R005 - DRAFT SEQUENCE - NOT INSTALLATION APPROVAL

Depth and sealing / review correction

05 / Install only the released material detail

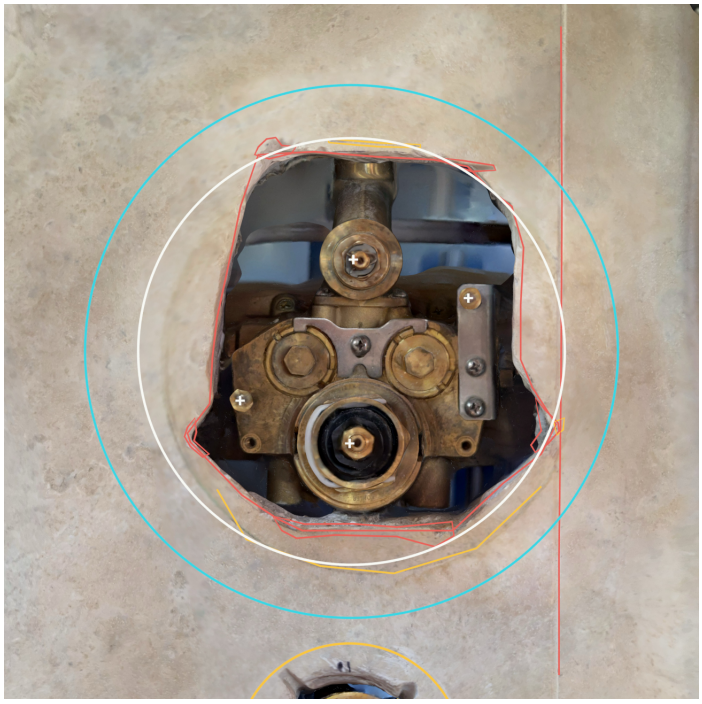
The current seated-cover trial has solid intersections and is rejected. No selected mortar, backing, sealant, finish or cure schedule exists. Do not install from this draft.

Control depth / diagnostic follow-up

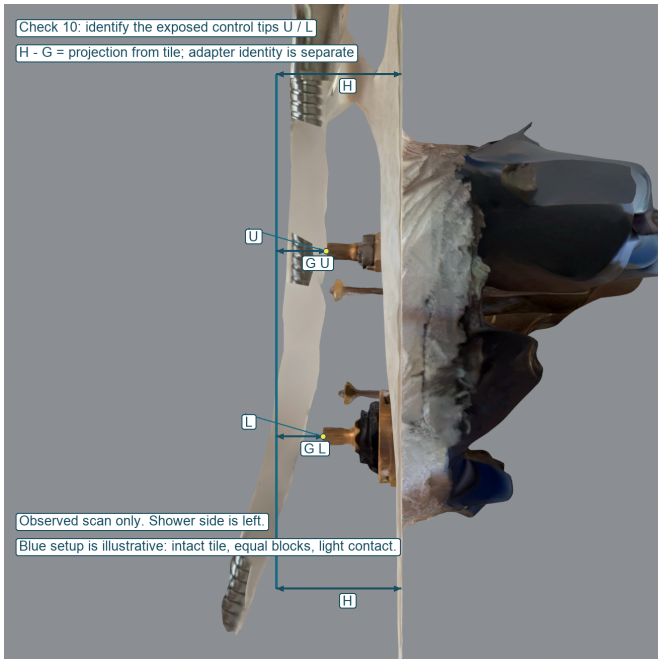
The user confirms excessive stud projection and reports rear bolt contact with wood. Trim studs thread into the valve; they do not need wood anchorage. Identify the same rear fasteners, framing/blocking and usable travel before selecting a remedy.

K-2973-KS specification p3: the labeled upper bare-tip and finished-wall dimensions imply a nominal upper-tip interval -6.3 to 27.0 mm from tile. Current comparison: 32.0 mm (conditional scan tip; identity and physical scale unverified). This is outside nominal interval if same bare tip. It is not a valve-relocation target.

Check 10 identifies the as-found tips/adapters and records block height H and both underside-to-tip gaps. H - G gives signed projection. The installer separately checks the plaster guard or documented axis datum. The 7/16-inch trim-stud limit does not apply to control stems.

Correct adapter and screw lengths must permit handle engagement and full cover/bonnet seating. An added backing plate changes that relationship again. Internal valve seals contain supply water; improper trim seating concerns external shower-water entry. Test these separately after the complete assembly is resolved.
